CMH1309 series

Comparison between Version 1.0 & 2.0

Comparison between CMH1309 Version 1.0 & 2.0

Appearance

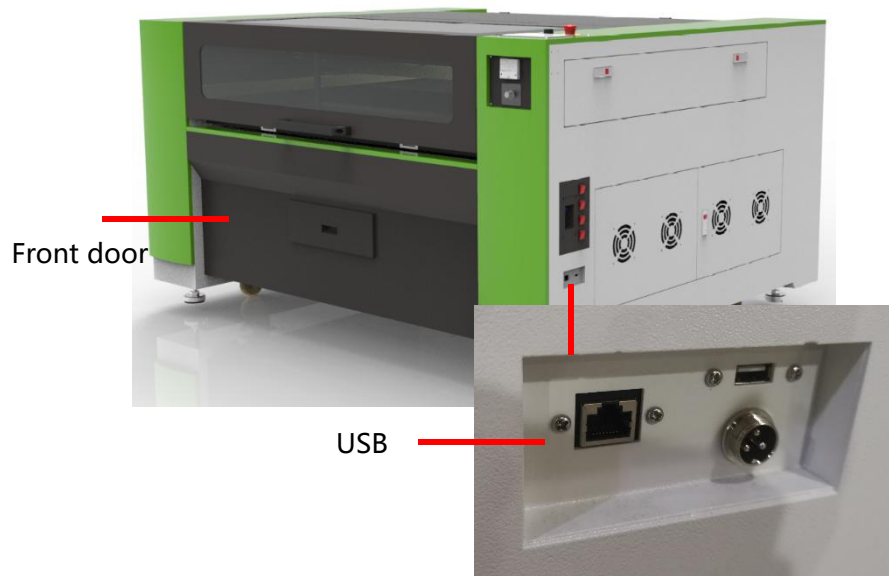
- The front cover is retracted, and the drawer is exposed.
- Cancel the drawer handle and change it with bending sheet.
- New structure Y-direction effective format up to 930mm
- Cancel the USB installation plate and install it directly on the chassis instead

Connecting plate

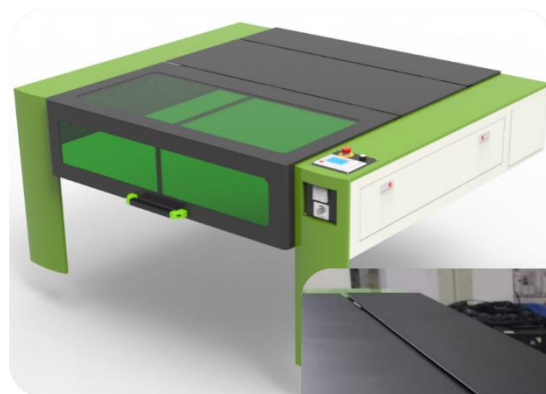
for repairing or adding the upper suction system

- Add a detachable door panel at the middle connecting cover plate, which can be used to repair the Y axis motor or to add upper blowing system (without replacing the middle connecting plate or making extra holes)

Up & Down table(appearance)

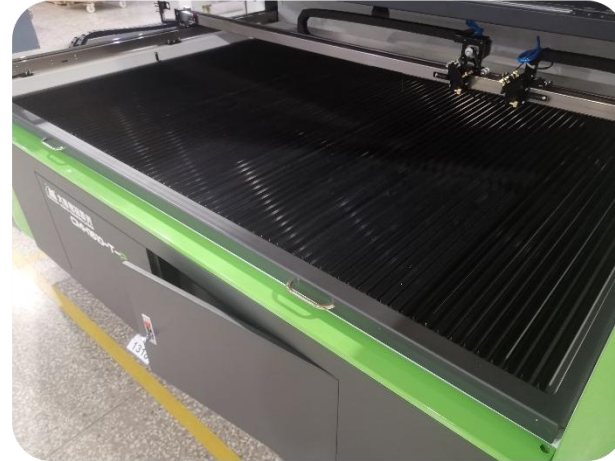
- There will be an extra magnetic door at front, which can be quickly opened to remove the internal drawers

Laser tube supporter

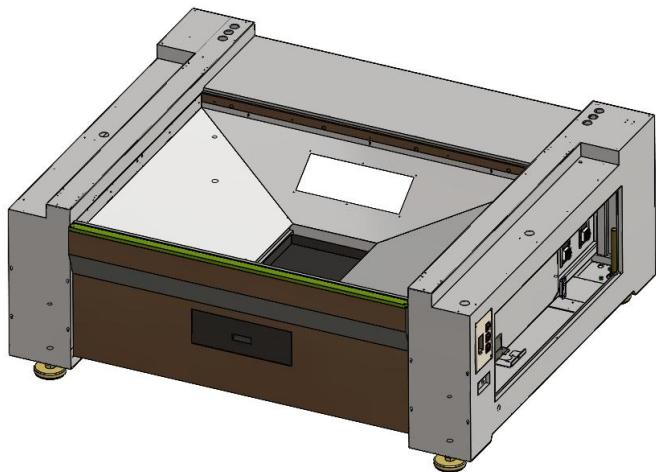
- The laser tube supporter is changed to specific plastic supporter.

Waste collector (optional)

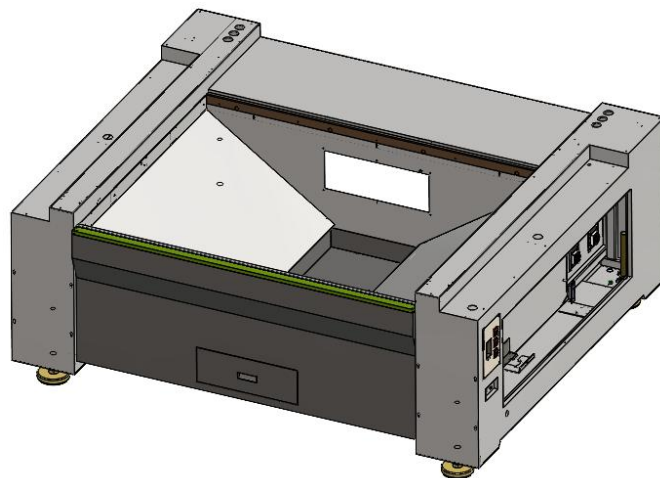
Two kinds of collector for different industries

Deduct the external frame of the slat and honeycomb table

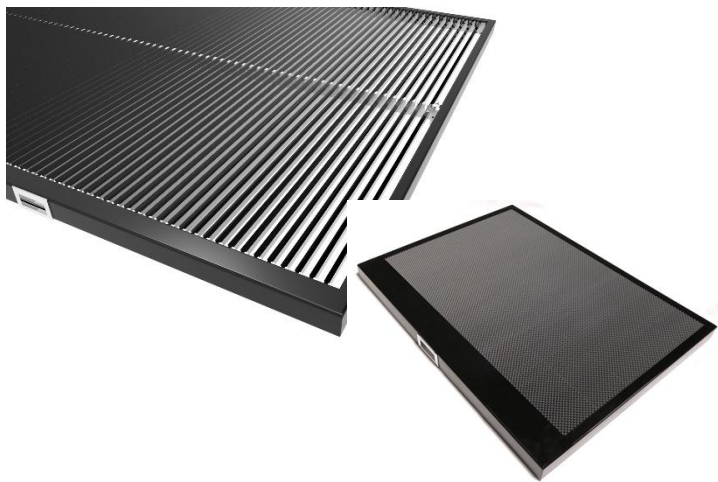
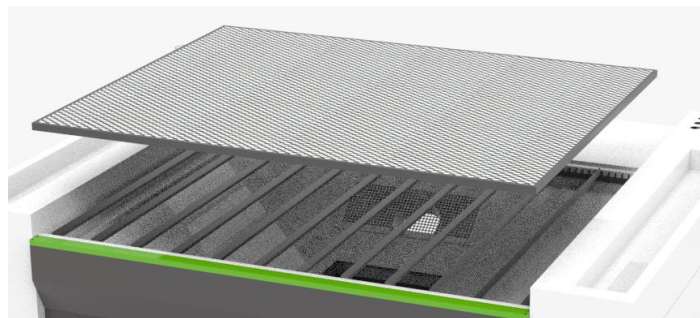
Deduct the external frame of the slate and honeycomb table

Use the slat as the frame of the table, and if the customer chooses honeycomb table, put the honeycomb onto the slat directly.

LED lamp

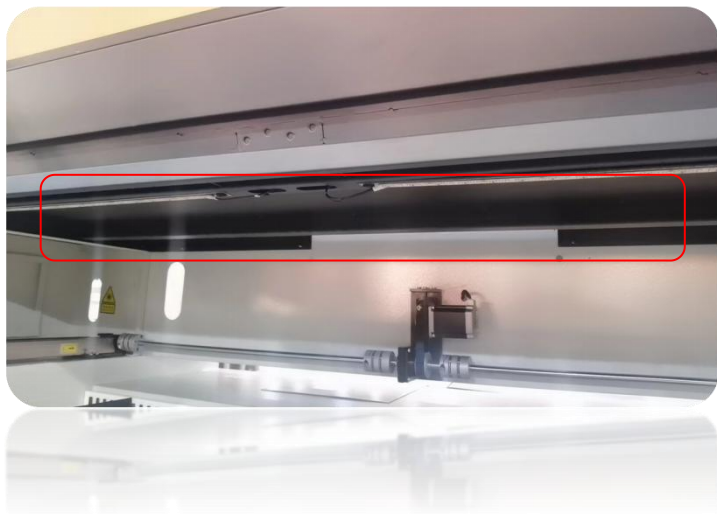
Change the LED lamp 300mm*2pc, 220V, to 500mm*2pcs, 24V, to reduce the difficulty of installation;
